STAFF REPORT ACTION REQUIRED

Sign Variance - 150 Eglinton Ave E

Date:	March 5, 2010
To:	Toronto and East York Community Council
From:	Director, Toronto Building, Toronto and East York District
Wards:	Ward 22 – St. Paul's
Reference Number:	2010TE085 10 120196 ZSV 00 ZR

Attachment 1: Site Plan

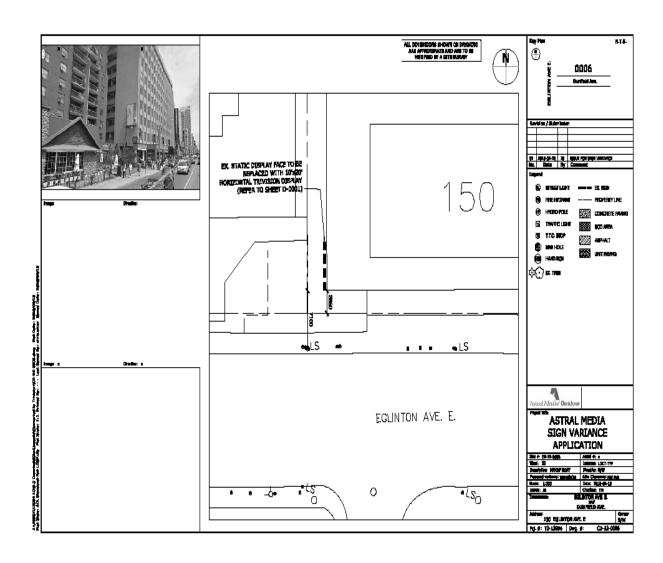
The variances are required because the proposed replacement third party fascia sign located on the west elevation of the building would contain rotating scroll copy attribute

which is not specifically described as a sign type and therefore it is not permitted. Also, the sign is not permitted because it would be located less than 20.0m from a lot in R zone. A fifteen storey residential apartment building is located on the adjoining lot to the west of this proposed sign. The sign would be visible from many of the residential apartments in that building. Also, the proposed sign does not meet the required 60.0m separation distance from other third party signs located in the vicinity.

In this instance, the proposal to replace the existing illuminated fascia sign with a newly designed illuminated fascia sign containing a horizontally rotating scroll copy attribute at 150 Eglinton Avenue is also not permitted under the current by-law. Staff can not justify recommending approval of the proposed fascia sign at this location.
